MONUMENT RIDGE EAST FILING NO. 1
WATER, SANITARY SEWER, AND SANITARY SEWER FORCE MAIN
PLAN & PROFILES
EL PASO COUNTY, COLORADO

MONUMENT RIDGE EAST
FILING NO. 1
UTILITY CONSTRUCTION DRAWINGS

V5_UT CDs.pdf Markup Summary

DESIGNED BY:	MGP	DRAWN BY:	MGP
SCALE:	1" = 40'	DATE:	04/28/25
JOB NUMBER	24-001	SHEET	10 OF 12

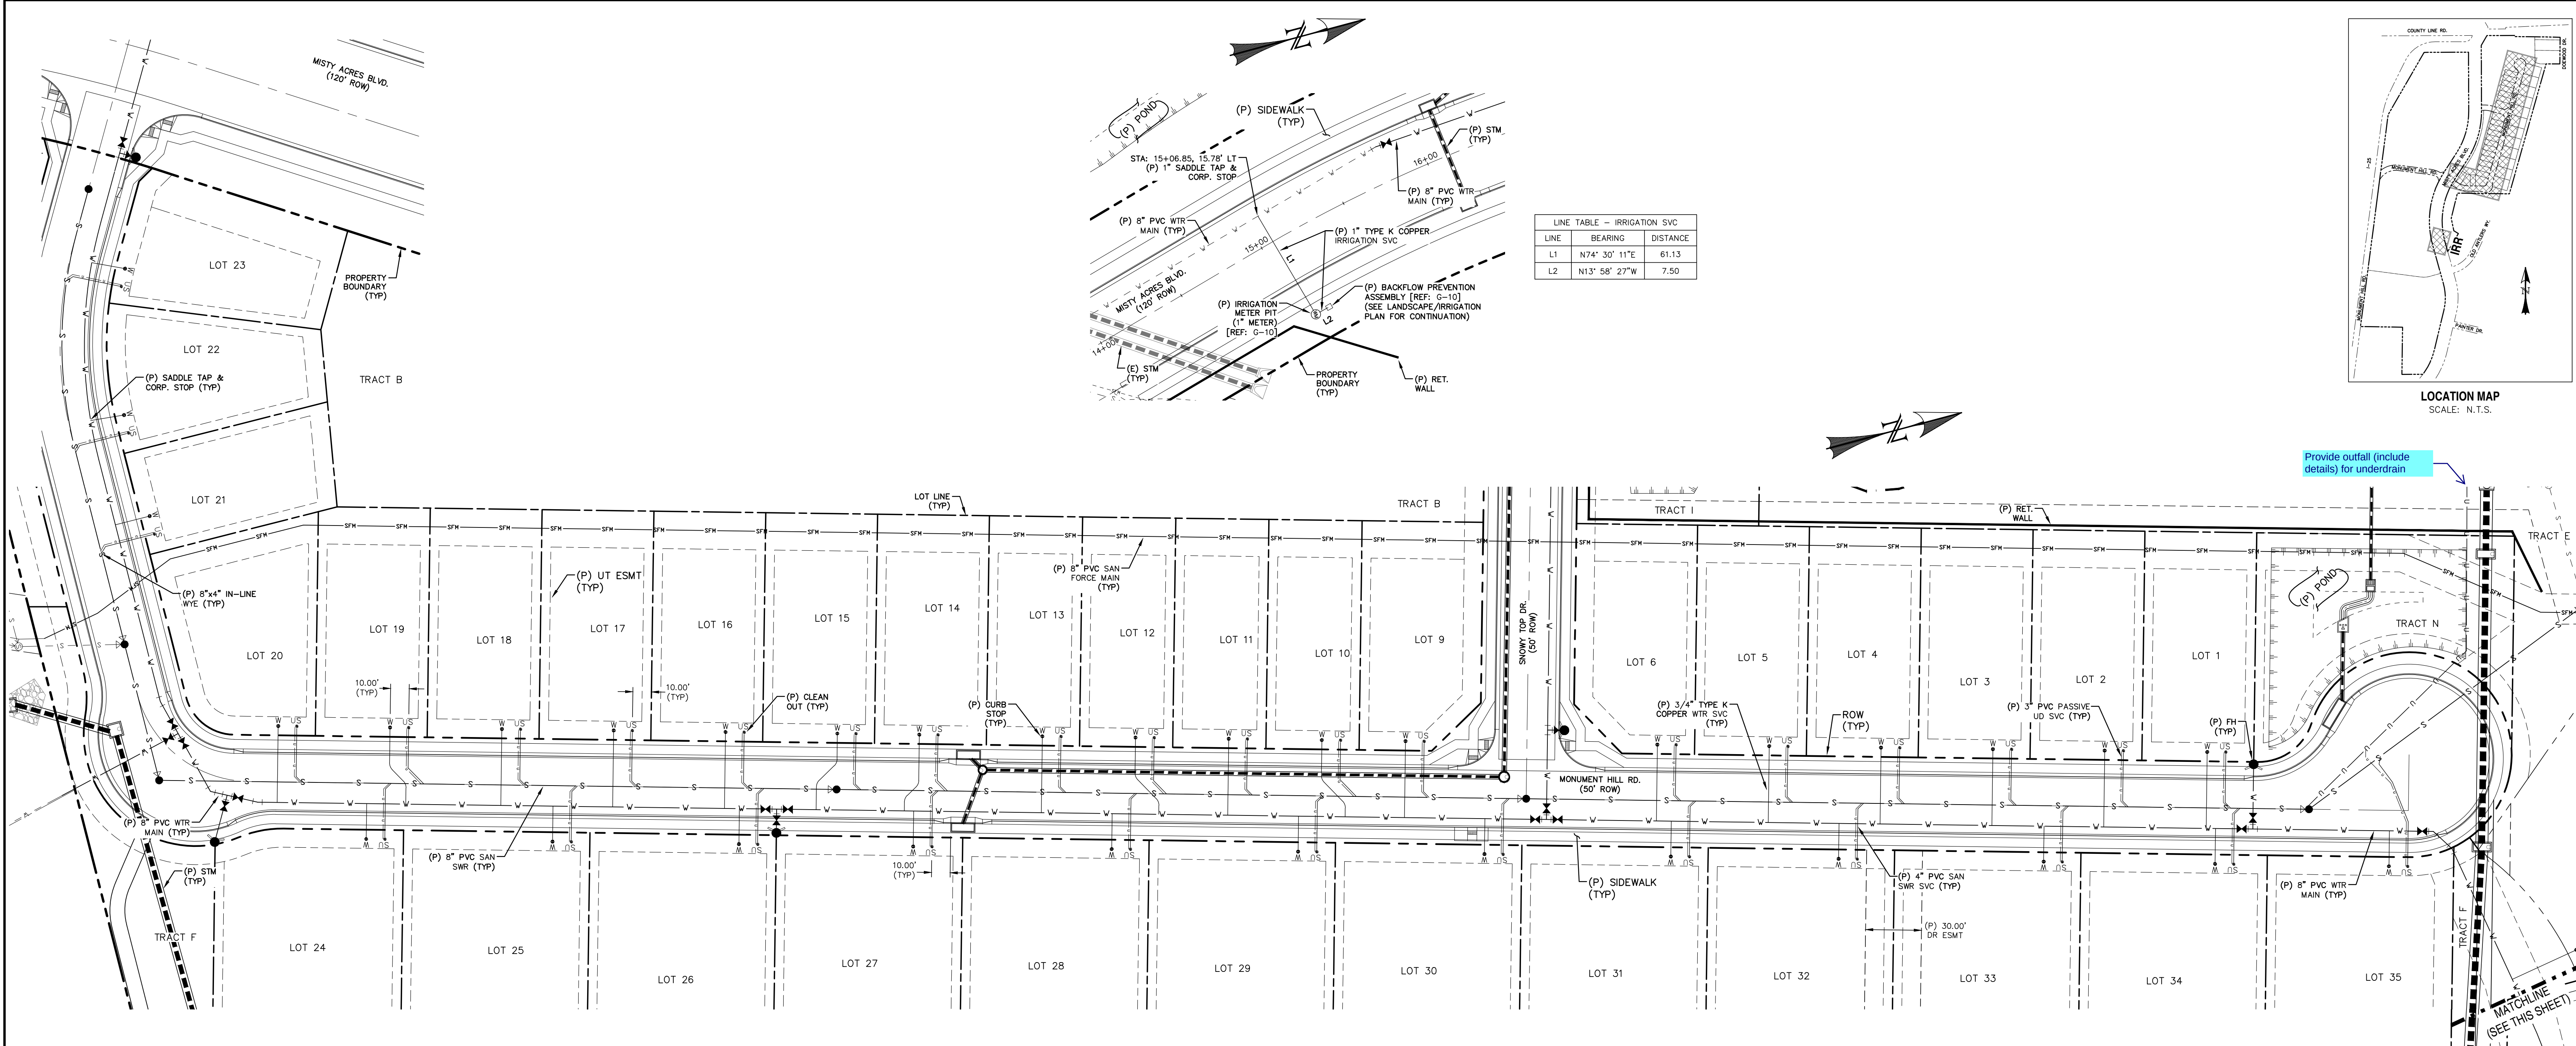
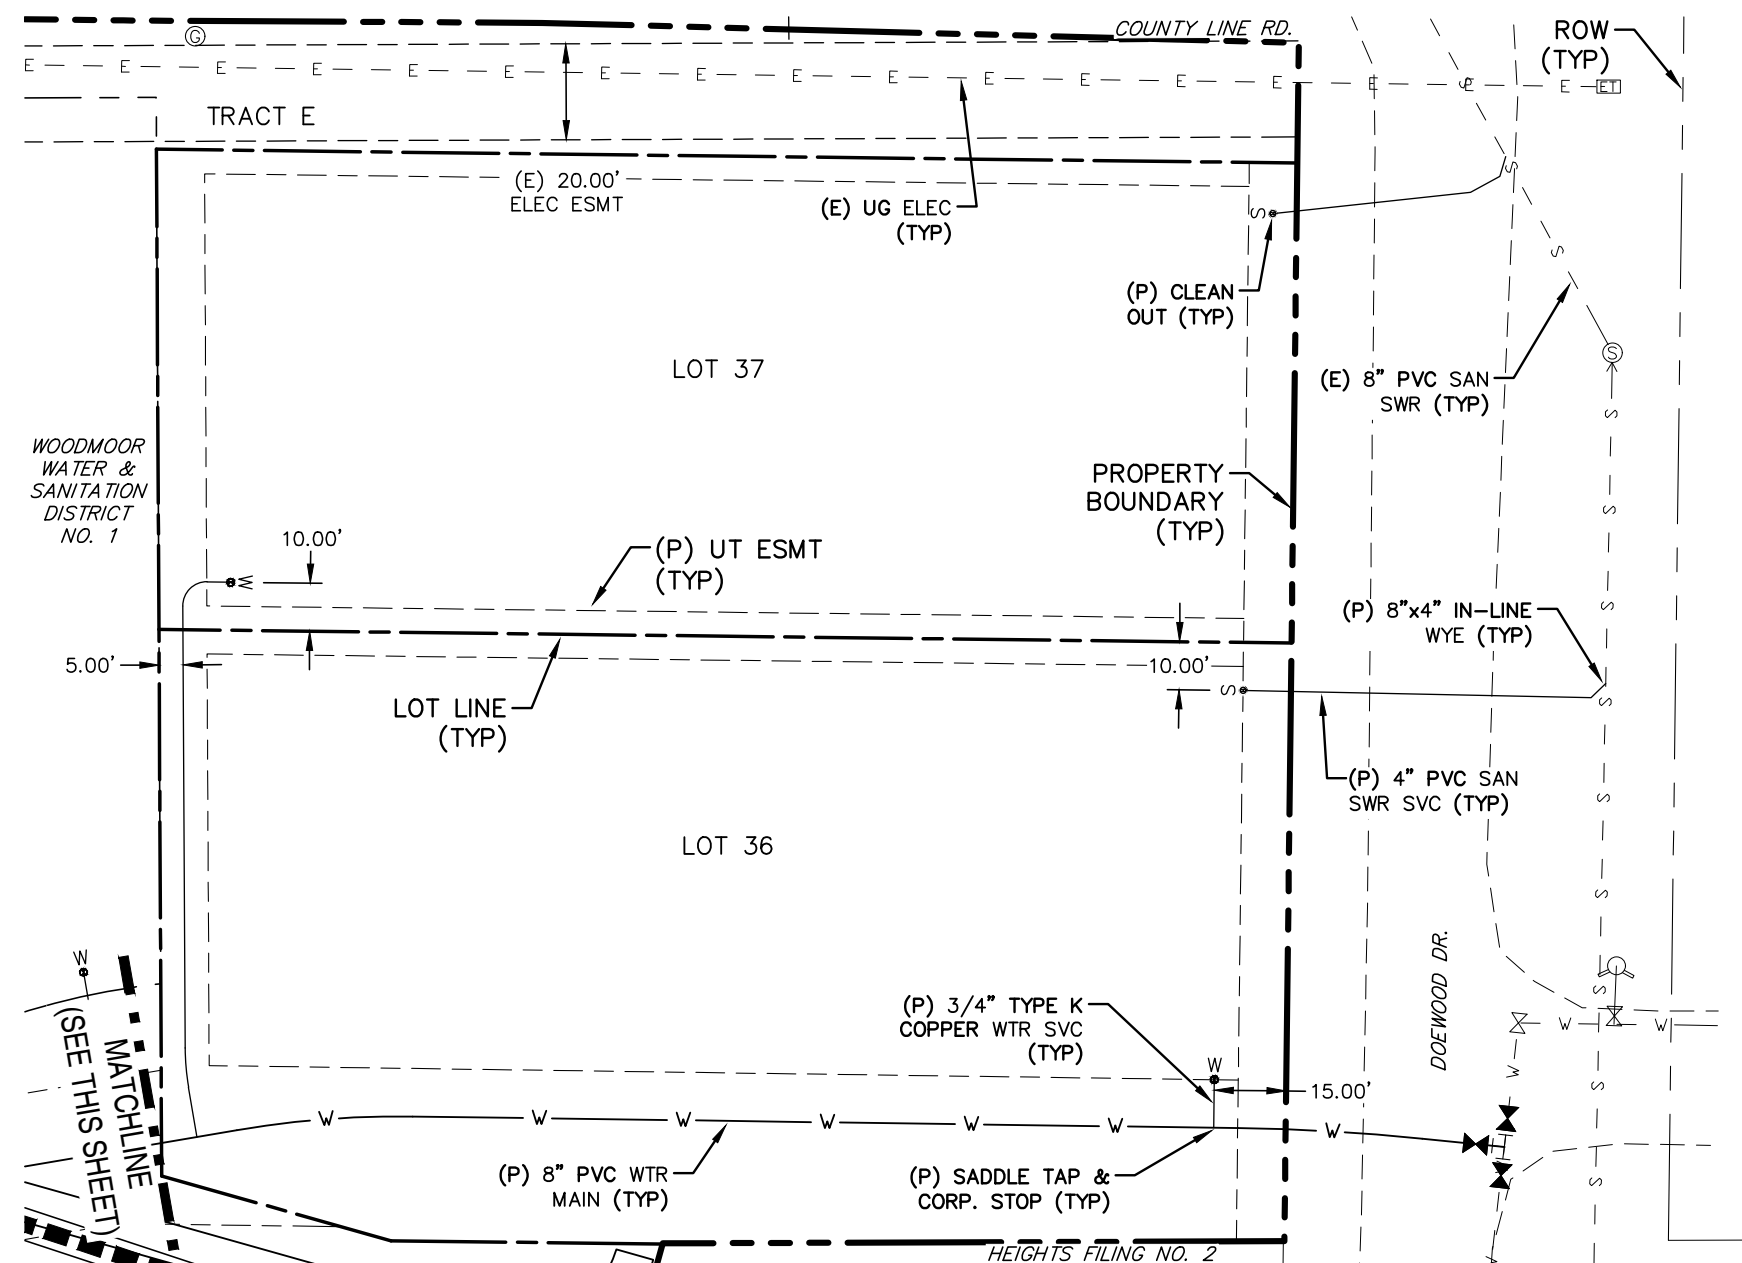
Add this note:

El Paso County does not own and is not responsible for the underdrains or groundwater discharge systems shown on these plans and assumes no liability for water rights administration by approving these plans. Maintenance and water rights are the responsibility of the developer and [] xx metropolitan district, or yy property owner's association[].

Provide outfall (include details) for underdrain
